DEVIATION REQUEST (Attach diagrams, figures, and other documentation to clarify request)

A deviation from the standards of or in Section **Chapter 6 6.4.1 and Table 6-4** of the Drainage Criteria Manual (DCM) is requested.

Rural Minor Collector – Arroya Lane
Allowable culvert overtopping – major drainage system maximum depth of 12"

RETREAT AT TIMBERIDGE FILING NO. 3
CONSTRUCTION PLANS
STREET IMPROVEMENT PLANS
ARROYA LANE

OVERTOPPING EXHIBIT

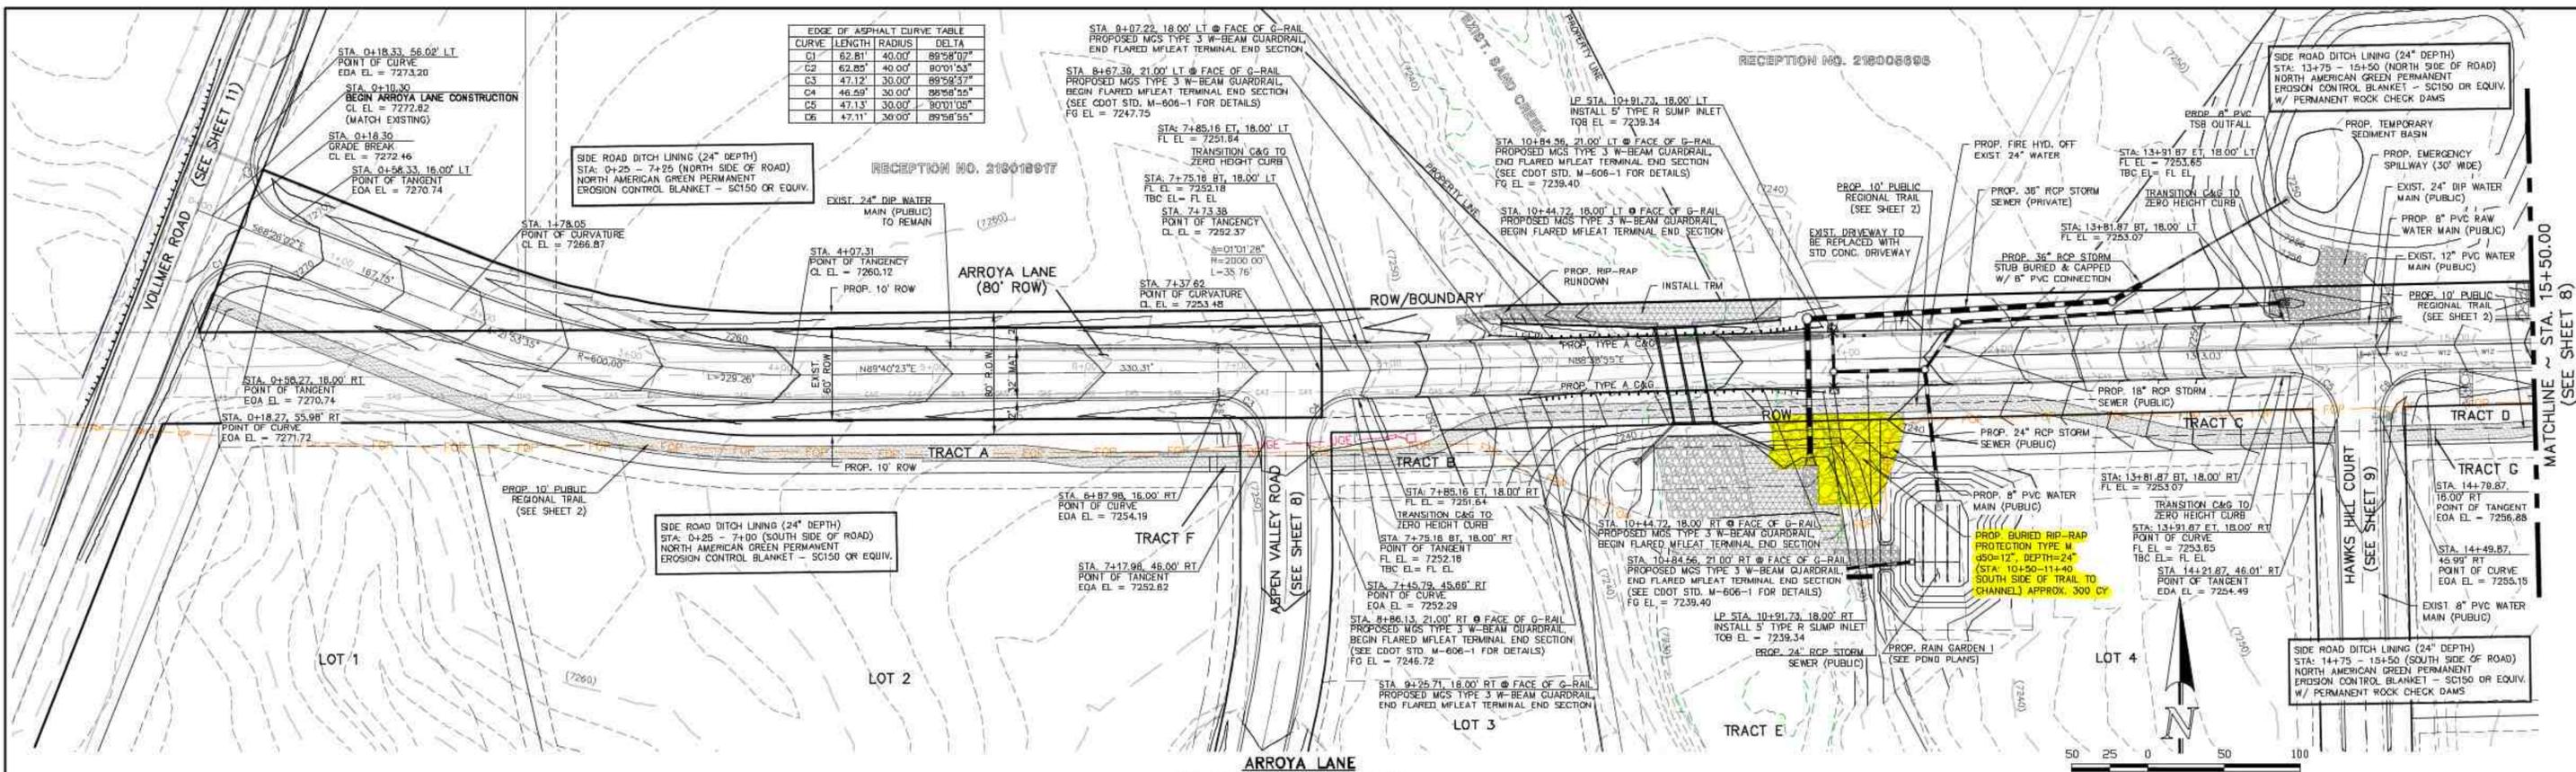
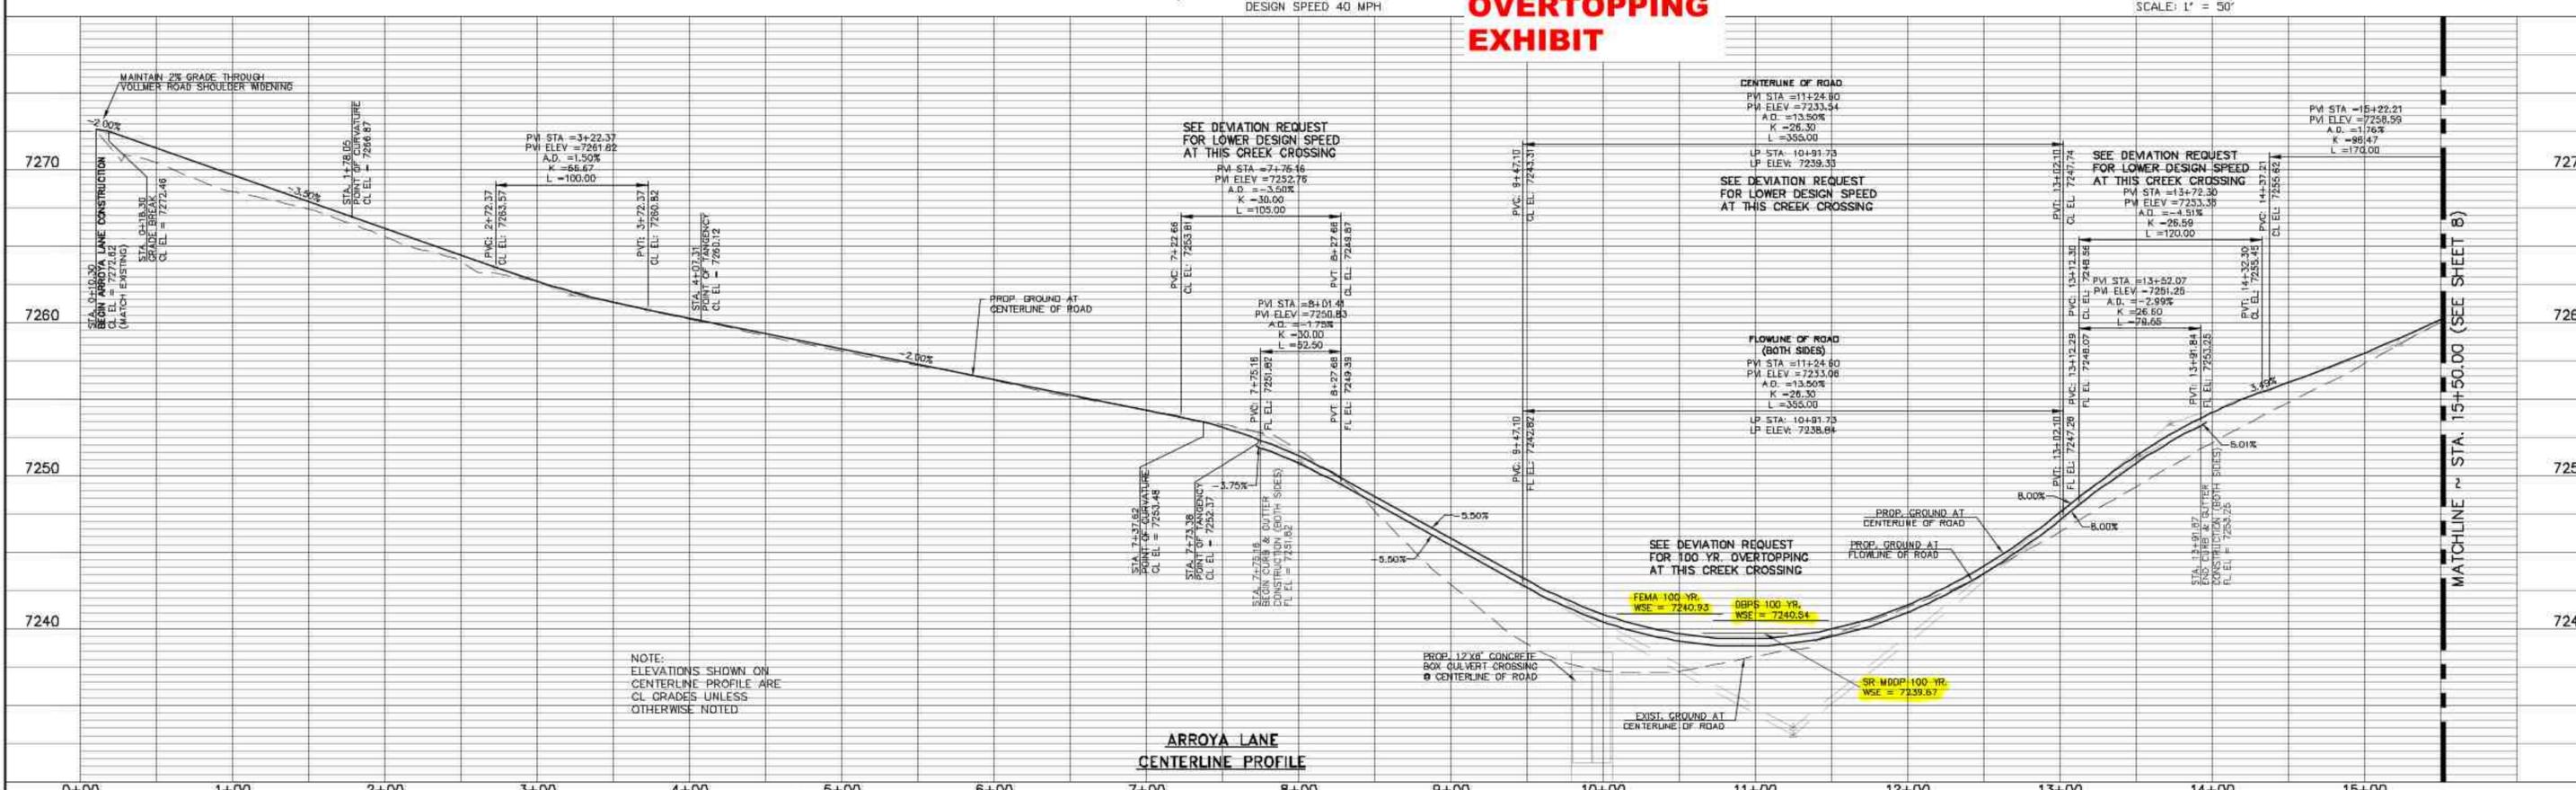
The adjacent property owner directly north of Arroya Lane currently has a private driveway with access onto Arroya Lane 125' east of the culvert crossing of Sand Creek. The current roadway and culvert crossing design required several temporary construction and permanent drainage easements from this property owner. After many discussions and meetings, this neighbor is unwilling to grant any easements for work on his property.

Thus, we have revised the roadway and culvert crossing design to accommodate no disturbance on the adjacent property. In order to make this design work by keeping his current private driveway location in tact yet still provide an adequate 100-yr. culvert crossing of Sand Creek, overtopping depth of a small portion of this roadway will exceed the max. 12" ponding for the Sand Creek DBPS and FEMA 100-yr. flows. (2170 cfs and 2600 cfs, respectively)

More specifically: SC DBPS 100-yr. flow of 2170 cfs will have a max. depth at the low-point in Arroya Lane. of 1.70'
FEMA 100-yr. flow of 2600 cfs will have a max. depth at the low-point in Arroya Lane of 2.09'

The proposed deviation, with additional warning signage and buried rip-rap embankment protection for this roadway overtopping will result in a comparable design for the roadway.
